Technical Change

At the moment the ZDU 2.5 and ZPE 2.5 products are manufactured in the established clamp carrier design.

Old version	New version

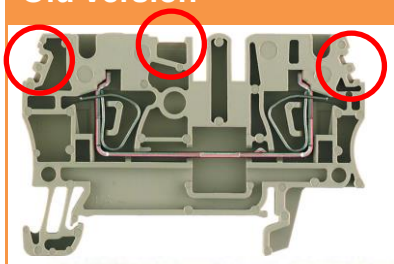
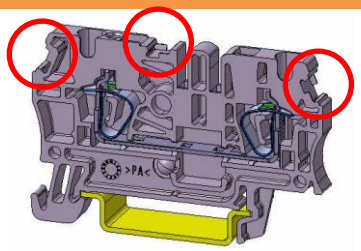
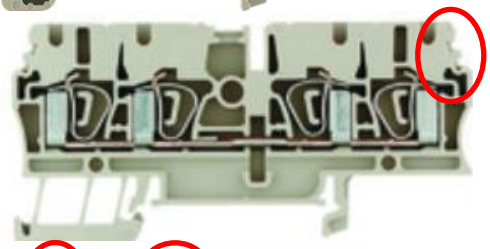
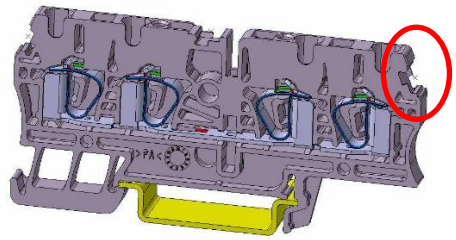
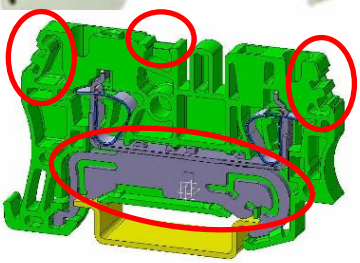
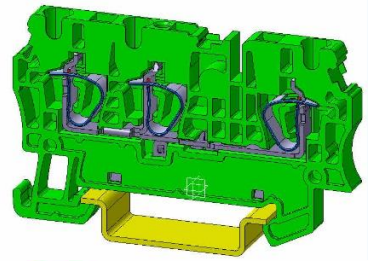
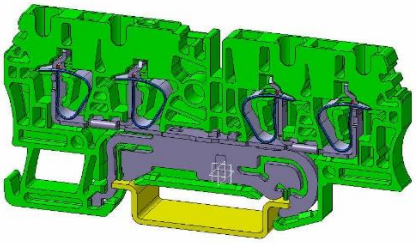
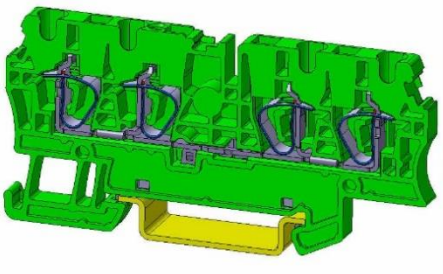
In the future, the affected products will be manufactured with new clamp carrier. Except for the ZDU 2.5 3AN variants, all affected products also have a new marking channel with lateral blades. This prevents the markers from slipping out.

The PE foot of the ZPE product variants will also be modified and will no longer be exposed, but enclosed on both sides by the plastic.

The PE terminals are still marbled green-yellow.

Above color representation of ZPE variants not accurate. The products have a green-yellow marbling, as in the following illustration:
